Technical Committee on Sprinkler System Installation Criteria

M E M O R A N D U M

SUBJECT: **AUT-SSI AGENDA PACKAGE – A2015 Pre-First Draft Meeting**

Enclosed is the agenda for the Pre-First Draft meeting for NFPA 13, *Standard for the Installation of Sprinkler Systems*. NFPA 13 has entered the Annual 2015 revision cycle and will produce a 2016 Edition. It is imperative that you review the attached public input in advance, with your ideas and substantiations for your views. If you have alternate suggestions for text changes, please come prepared with the words and respective substantiation.

FIGURE 8.6.4.1.4(b) Sprinklers Under a Roof or Ceiling in Combustible Concealed Spaces of Wood Joist or Wood Truss Construction with Members 3 ft (0.91 m) or Less on Center and a Slope Having a Pitch of 4 in 12 or Greater.

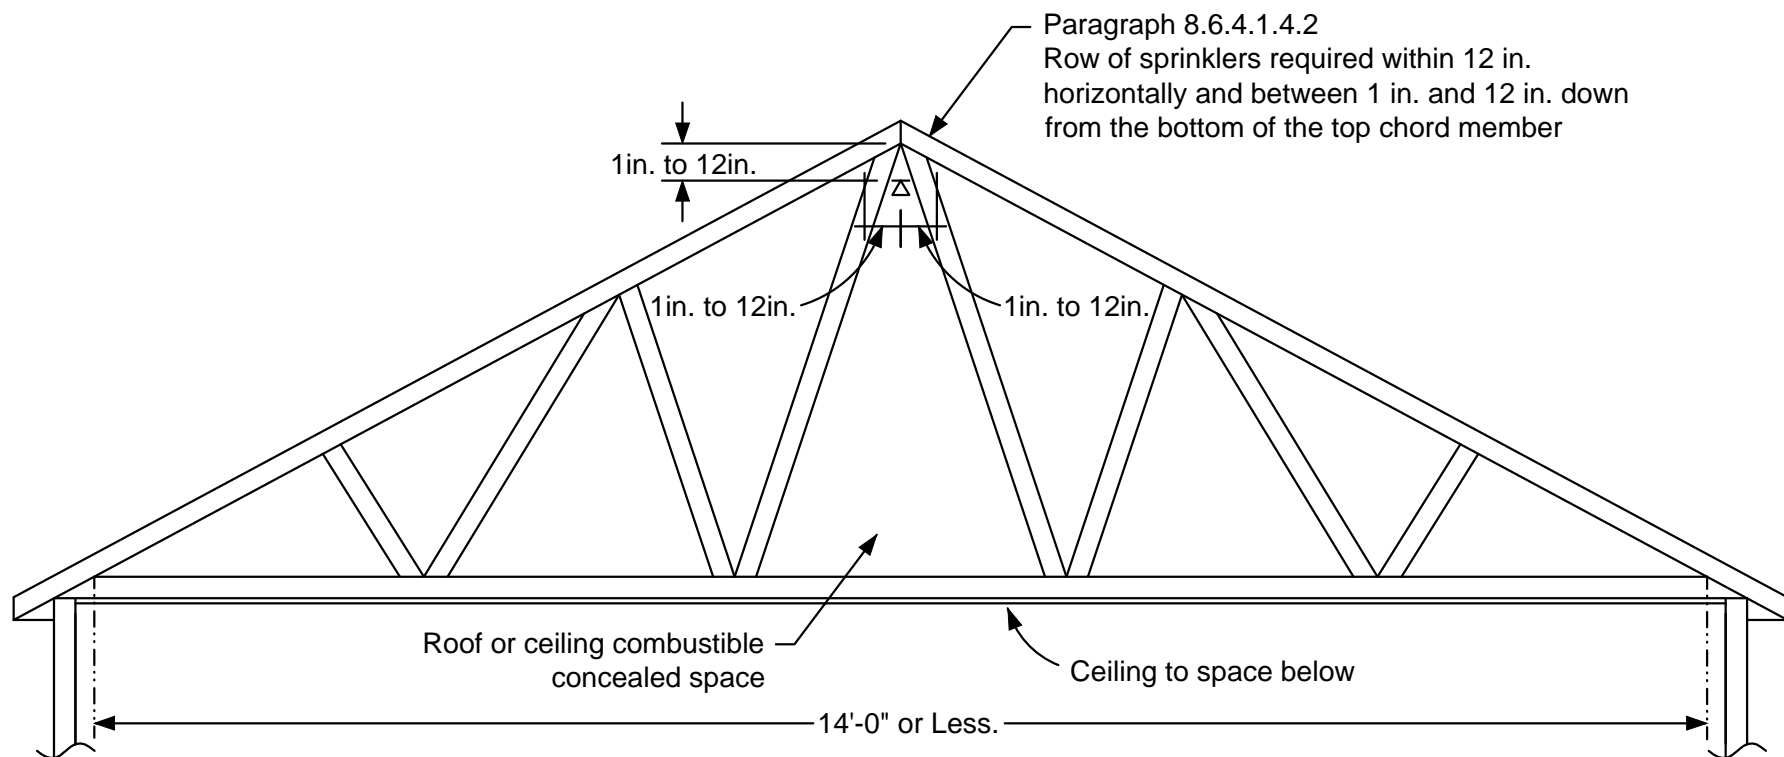
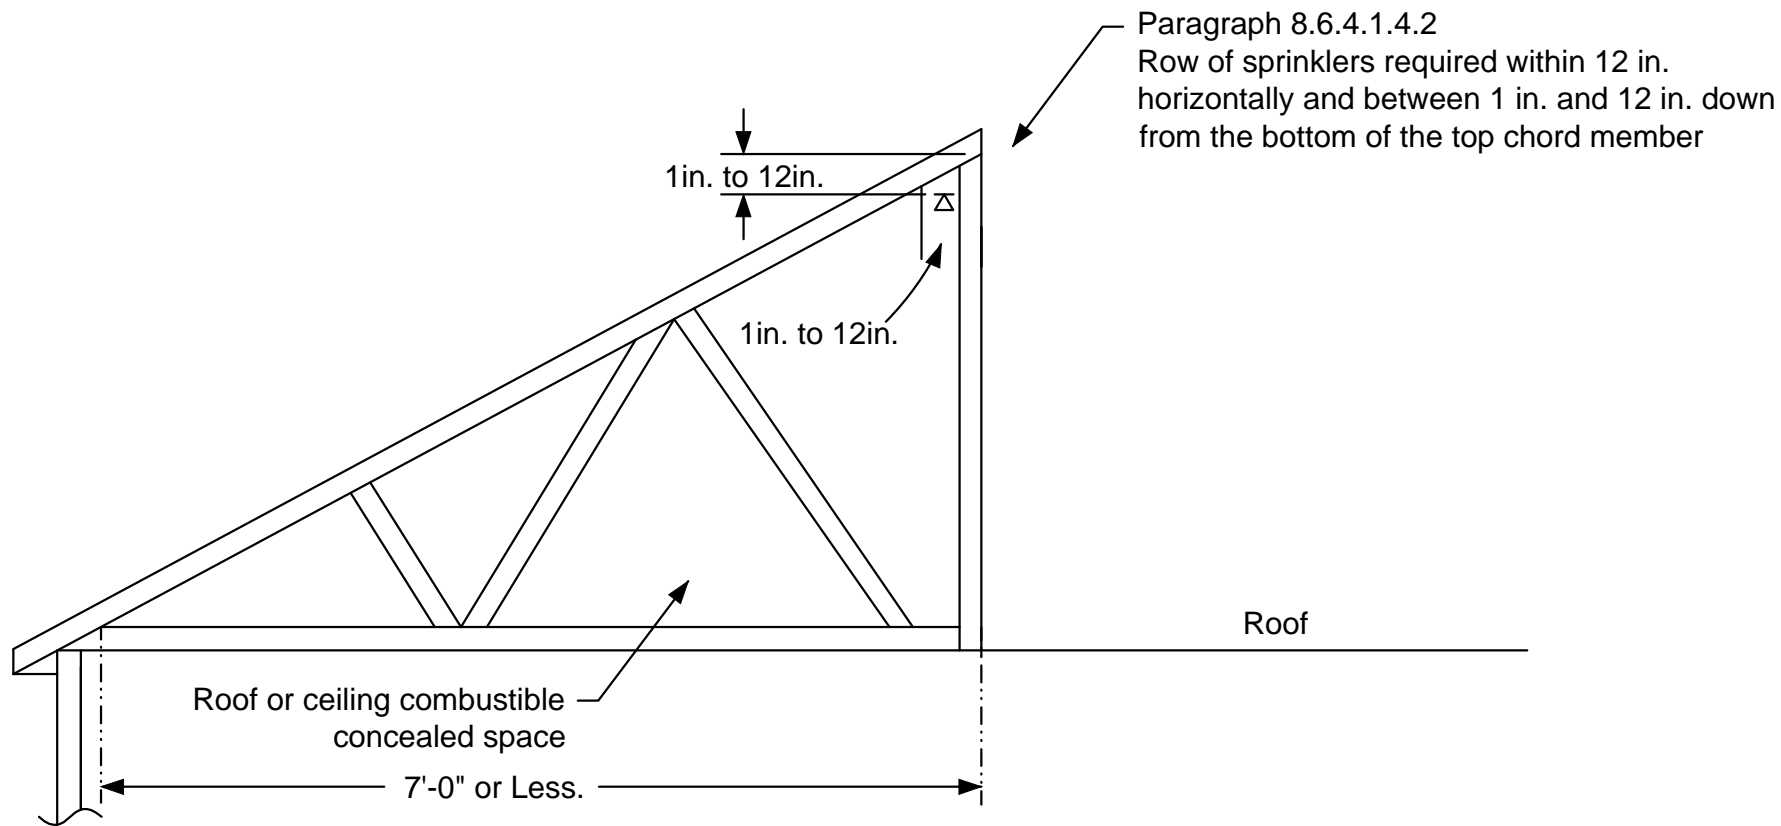
Sprinklers shall be positioned in accordance with ~~Figure Figures 8.6.4.1.4 and (a), 8.6.4.1.4 (b) or 8.6.4.1.4 (c) and~~ the requirements of 8.6.4.1.4.1 through 8.6.4.1.4.5.

~~Figure 8.6.4.1.4 Sprinklers Under Roof or Ceiling in Combustible Concealed Spaces of Wood Joist or Wood Truss Construction with Members Less Than 3 ft (0.91 m) on Center and Slope Having Pitch of 4 in 12 or Greater.~~

FIGURE 8.6.4.1.4(c) Sprinklers Under a Roof or Ceiling in Combustibile Concealed Spaces of Wood Joist or Wood Truss Construction with Members 3 ft (0.91 m) or Less on Center and a Slope Having a Pitch of 4 in 12 or Greater.

[Figure 8.10.7.1.3 Positioning of Sprinkler to Avoid Obstruction \(Residential Sidewall Sprinklers\)](#)

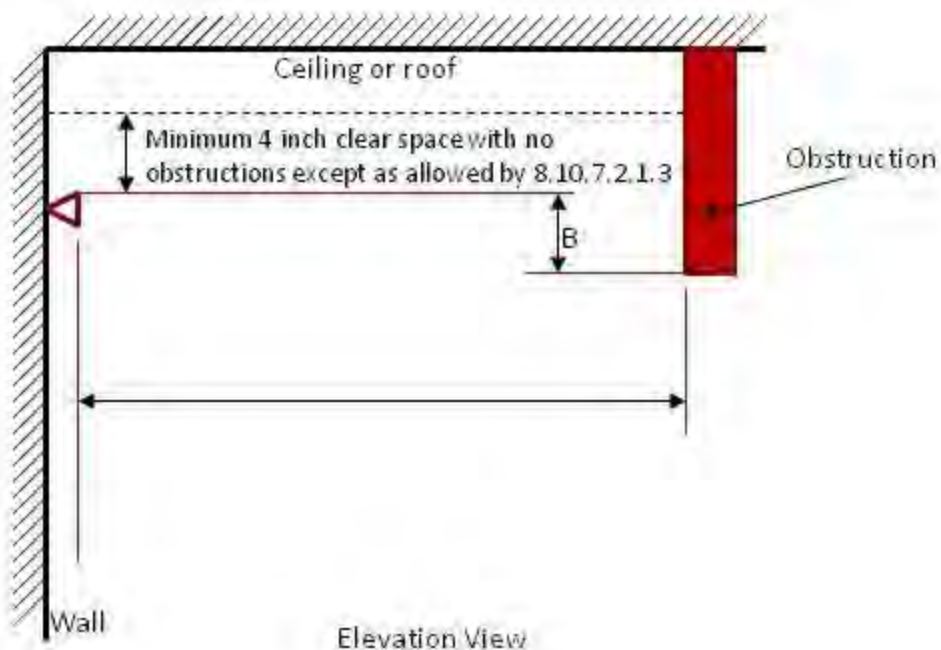
File Name	Description	Approved
Open 8-10-7-1-3.jpg	Our intent is just to replace the existing Figure 8.10.7.1.3 with new Figure 8.10.7.1.3

Our new Figure 8.10.7.1.3 attempts to clarify two issues with respect to the beam rule and sidewall sprinklers. First, we wish to clarify that when sprinkler spray needs to get under an obstruction, there needs to be some clear space above the sprinkler deflector. Too many people using NFPA 13 think that the obstructions at the same elevation as the deflector are acceptable (which would be true for pendent and upright sprinklers). But sidewall sprinklers need 4 inches of clear space above the deflector as well.

Our second concern is a clarification of the type of obstruction applicable to this rule. Skinny obstructions that meet the "four-times rule" should not have to worry about water spray only going under the obstruction. In this case, the four-times rule (as modified by our Public Input on section 8.10.7.2.1.3) should be sufficient for sprinkler spray patterns to develop. A 4 inch wide light fixture is not going to be any worse than a 4 inch wide column using the four-times rule.

This is a new Figure 9.1.5.7.2

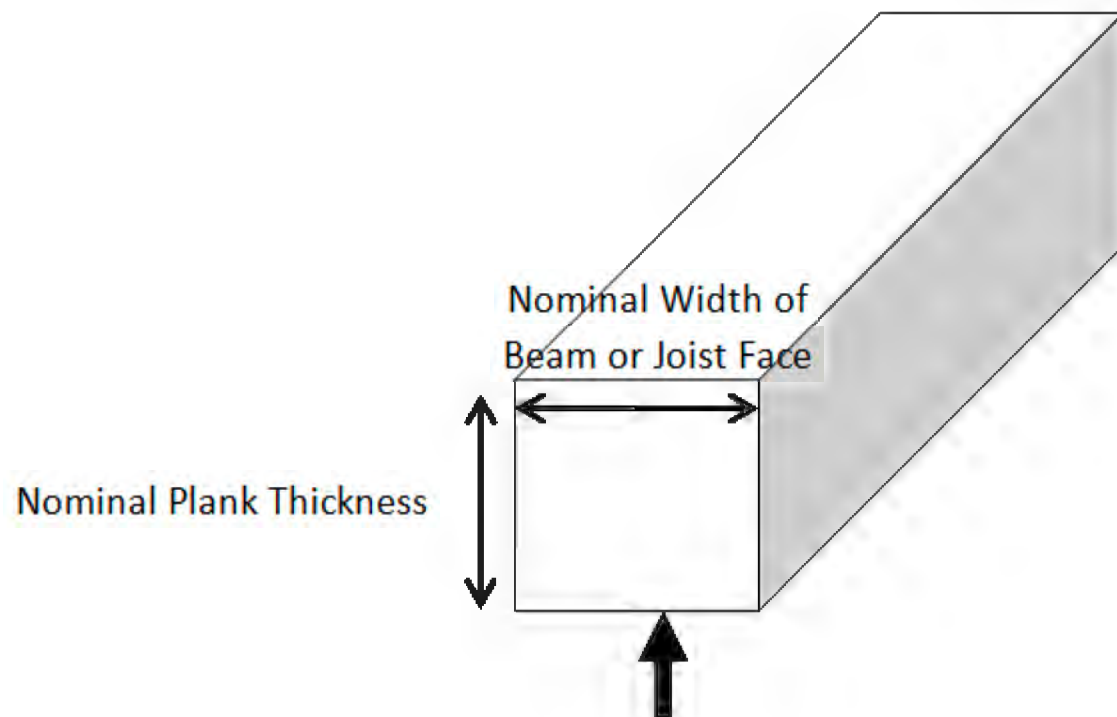
The minimum plank thickness and the minimum width of the lower face of beams or joists in which coach screw rods are used shall be not less than that specified in Table 9.1.5.7.2 and shown in Figure 9.1.5.7.2.

<u>File Name</u>	<u>Description</u>	<u>Approved</u>
<input type="button" value="Open"/> Average_Spacing.pdf	Figure A.11.3.1.3 (a)

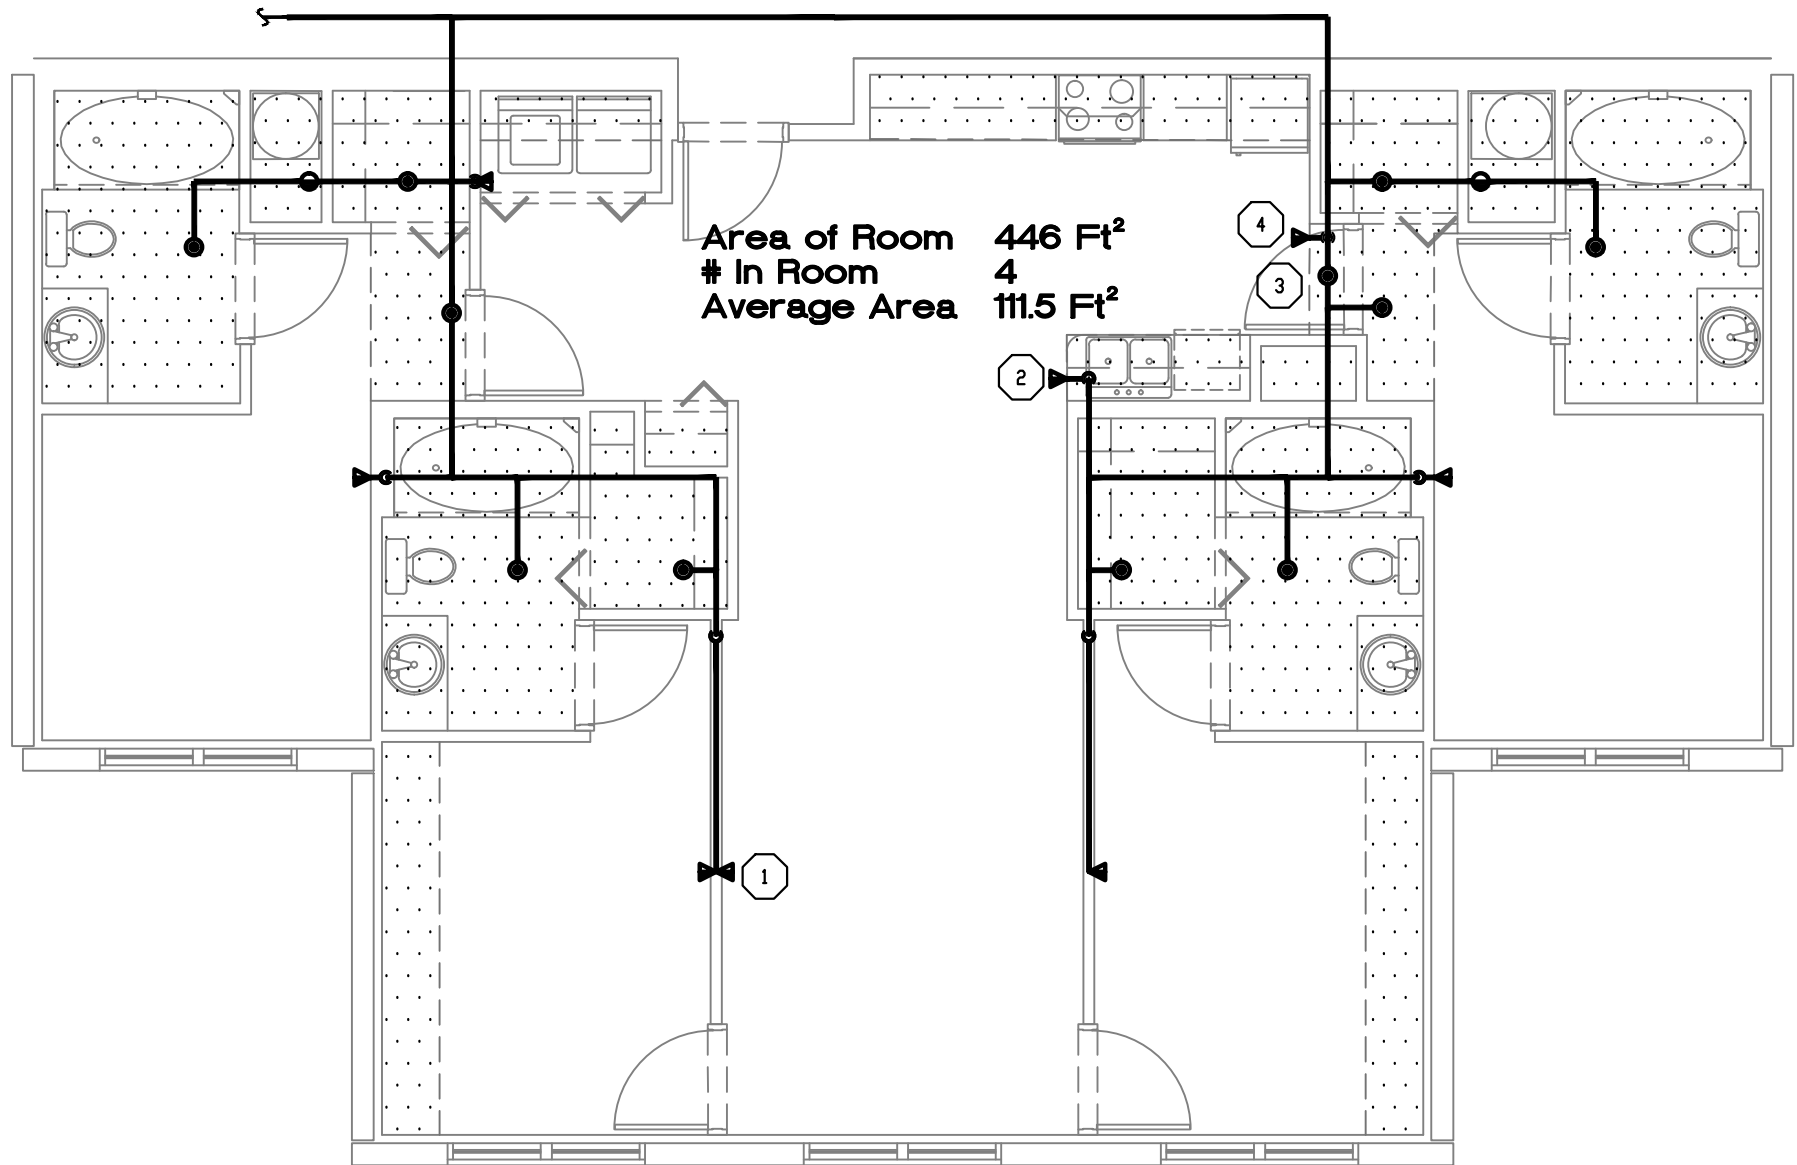
The average spacing of the sprinklers in rooms or compartments 800 ft² (74.3 m²) or less is determined by dividing the number of sprinklers in the room or compartment into the area of the room or compartment. See Figure A.11.3.1.3 (a).

Figure 16.1.2.4.1

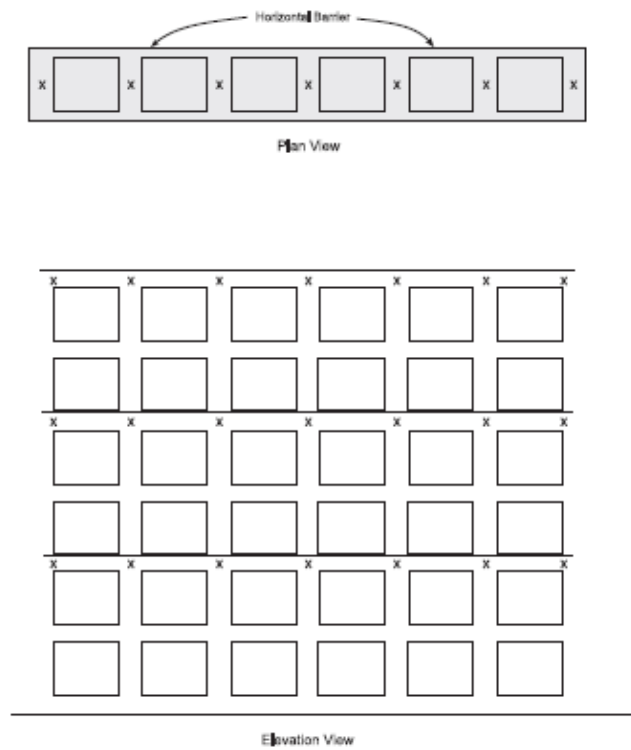
16.1.2.3.4.1 For single-row racks, sprinklers shall be installed at each rack upright as well as at each rack mid-bay as shown in Figure 16.1.2.3.4.1. The maximum linear spacing between sprinklers shall not exceed 5 ft (1.5 m).

16.1.2.3.4.2 For double-row racks, sprinklers shall be installed at each rack upright within the longitudinal flue space as well as at the face of the rack and at the mid-bay face of each rack bay as shown in Figure 16.1.2.3.4.2. The maximum linear spacing between sprinklers shall not exceed 5 ft (1.5 m) at the rack face and 10 ft (3.0 m) within the longitudinal flue space.

16.1.2.3.4.3 For multiple-row racks, an alternating sprinkler arrangement shall be installed within adjacent transverse flue spaces as shown in Figure 16.1.2.3.4.3 with sprinklers at the face of each flue space. The maximum linear spacing between sprinklers at the face and each alternating bay shall not exceed 5 ft (1.5 m) and shall not exceed 10 ft (3.0 m) between sprinklers at every other bay.

Figure 17.1.2.8.4.1

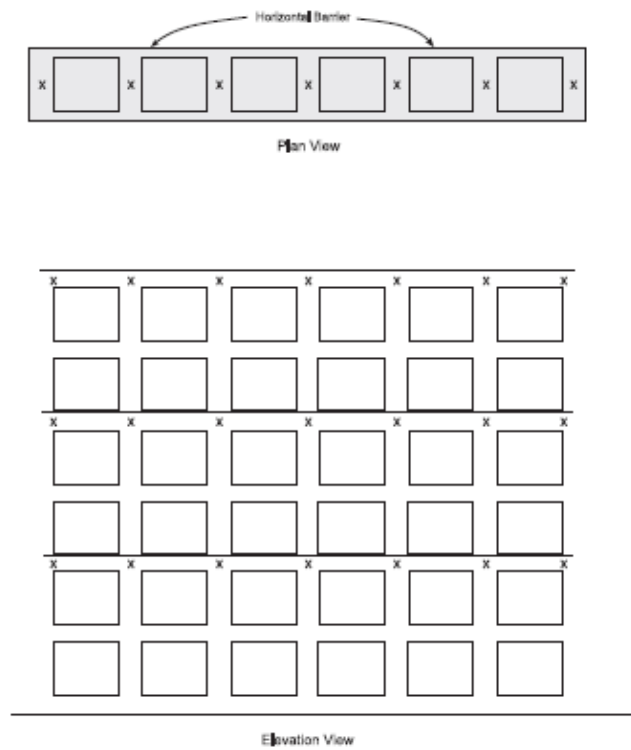
Minimum K8.0 (K115), quick-response sprinklers (ceiling-level or in-rack) shall be installed beneath each horizontal barrier. The deflector of the sprinkler shall be located as close to the underside of the horizontal barrier as possible.

Figure A.8. 16 17. 4 2. 1 Examples 4 Examples of Acceptable Valve Arrangements.

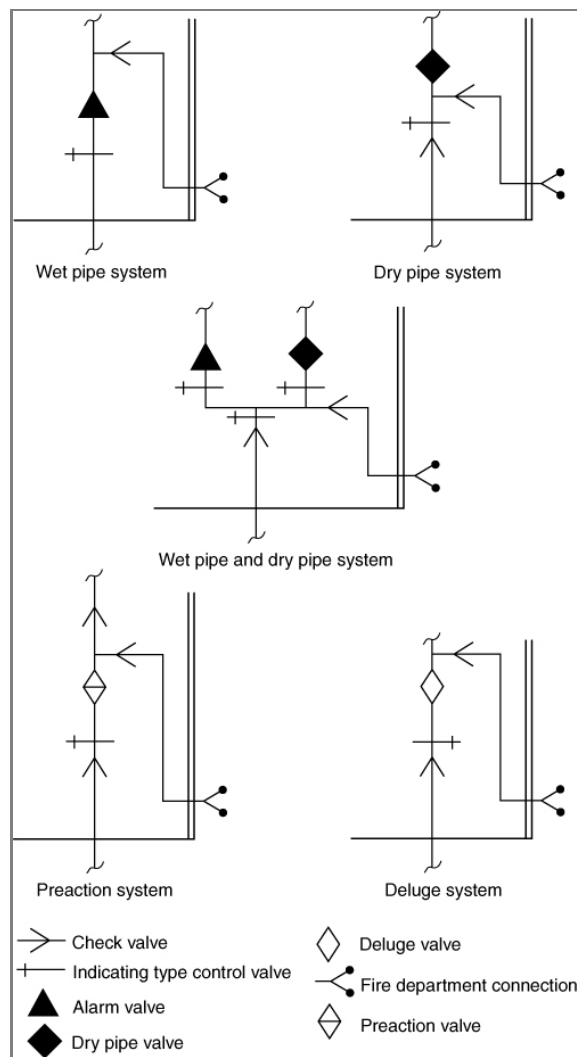
A.8. ~~16~~ 17 + 2 + 4 = 23

See Figure A.8. 46 17. 1 2. 4 4.
